# UNITED STATES PATENT AND TRADEMARK OFFICE

APPLICATION NO.	FILING DATE	FIRST NAMED INVENTOR	ATTORNEY DOCKET NO.	CONFIRMATION NO.
10/826,569	04/16/2004	Fiona Jaswant Singh Sheeran	SHE04.1001	1753

### **DETAILED ACTION**

This is the second Office Action **final** for serial number 10/826,569, Accessory Hanger, filed on April 16, 2004.

FIG. 1

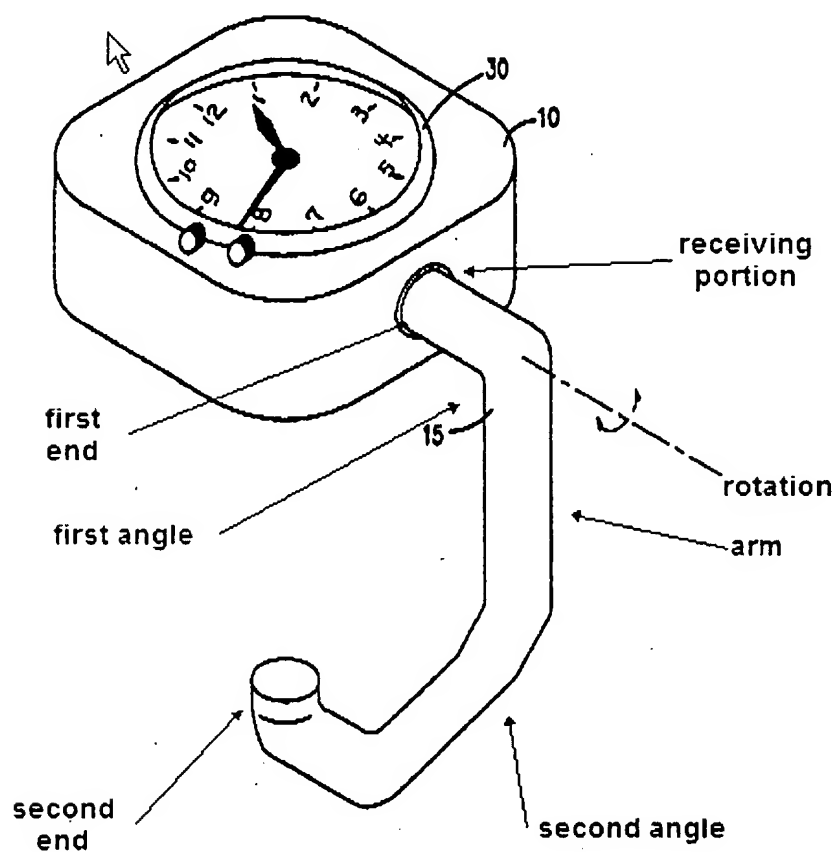
Lo '419 discloses a support base (10) having a receiving portion (fig. 1) that at least substantially transverses a support base; an arm (15) having a first end and a

second end, a first angle, and a second angle (fig. 1), and wherein a first end is inserted into a receiving portion so that it rotatably engages a support base (10).

Applicant argues that Lo '419 fails to disclose two elements. The Examiner clearly disagrees. Attention is directed to Lo '419 – figure 1 (see below), Lo '419

discloses a support base (10), an arm having a first end and a second end, a first angle and a second angle, wherein the first end is inserted into the receiving portion so that it rotatably engages the support base. As for the first element, it is not clear or doesn't make sense with "a support base having a receiving portion that at least substantially transverse the support base." See Claim Objection.
